Central Hudson Gas and Electric Corporation
A&C REBUILD PROJECT - ARTICLE VII APPLICATION
Case 13-T-0469

INTERROGATORY/DOCUMENT REQUEST

Requesting Party and No.: DPS Staff - DPS-001 (MS)

Central Hudson Response No: CHGE-001 (DPS)

A & C 115KV LINES
EMF R.O.W. CROSS SECTIONS
SHEET 6 OF 8

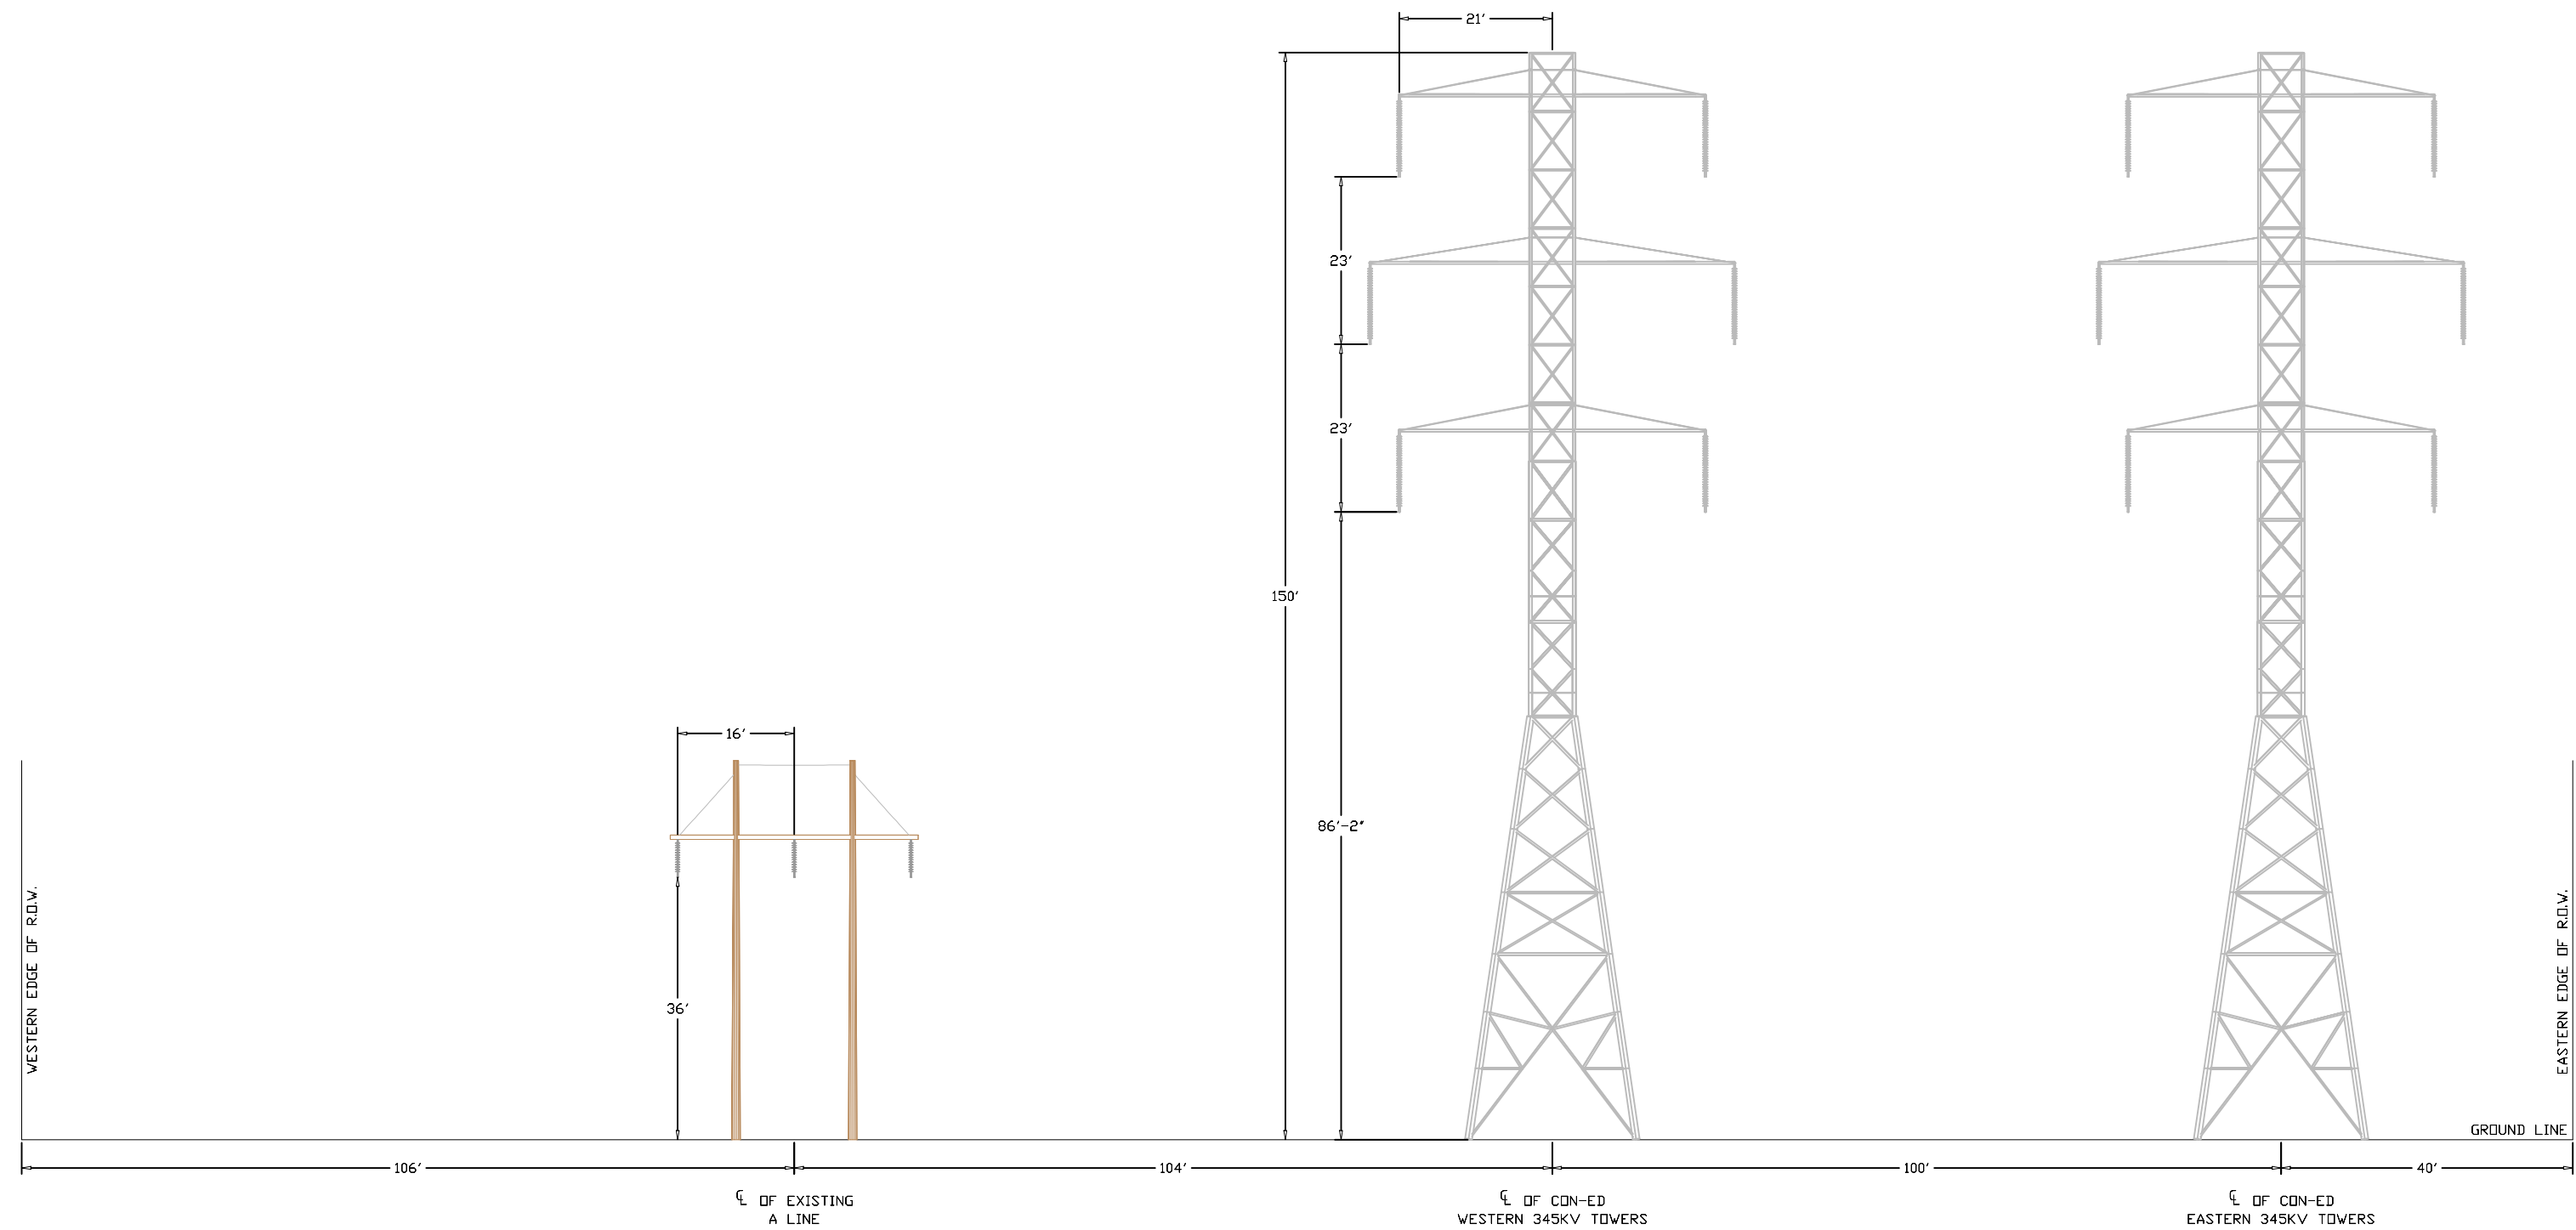
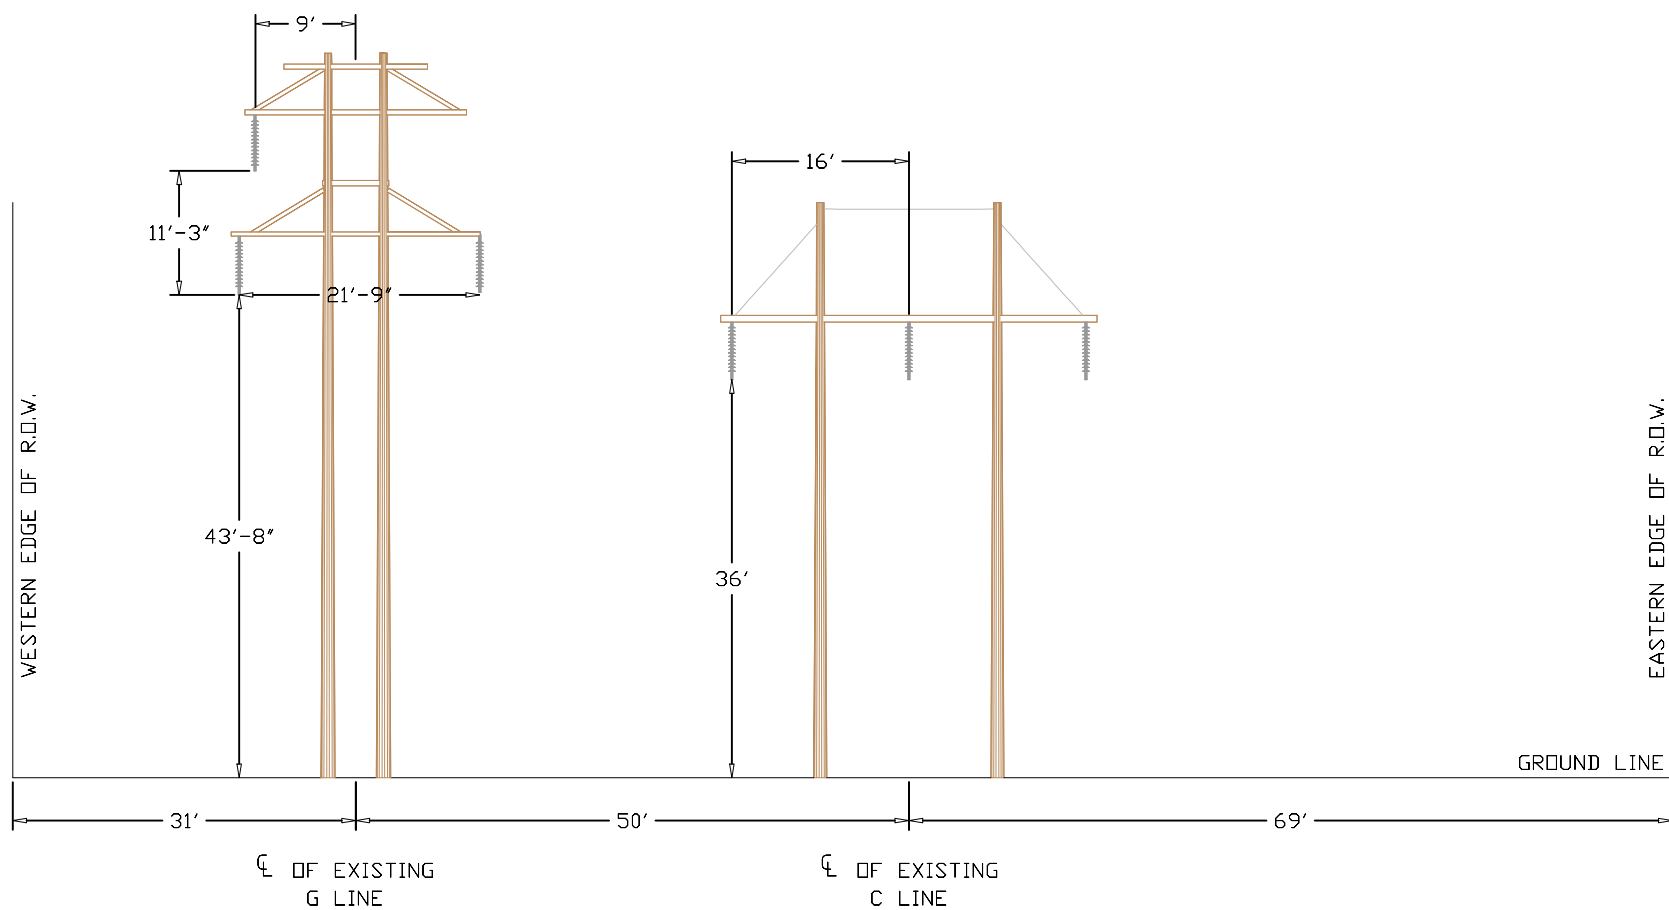
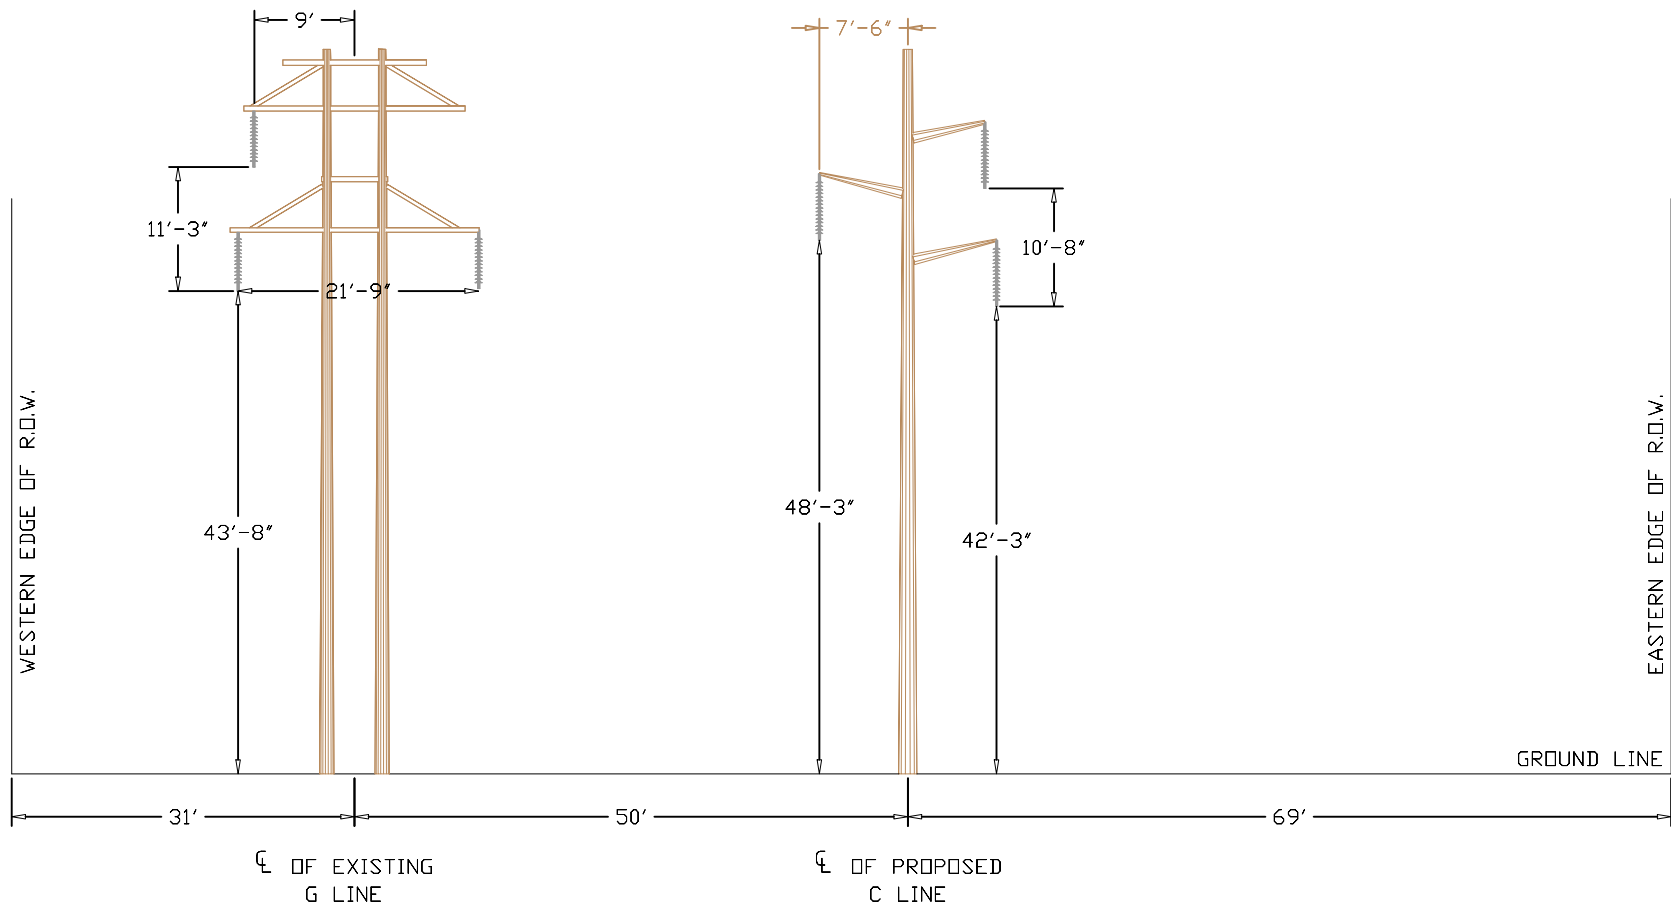
Provide the engineering drawings for the Consolidated Edison-owned lines and the Central Hudson Gas and Electric Corporation-owned A&C lines used to calculate the EMF levels that were provided in the Application for various portions of the right-of-way (ROW). The drawings should be to scale and include the dimensions of the structure and spacing of the conductors and ground wires.

*The drawings used to calculate the EMF levels are the cross-sections (8 sheets) attached as **Exhibit A** to this Response.*
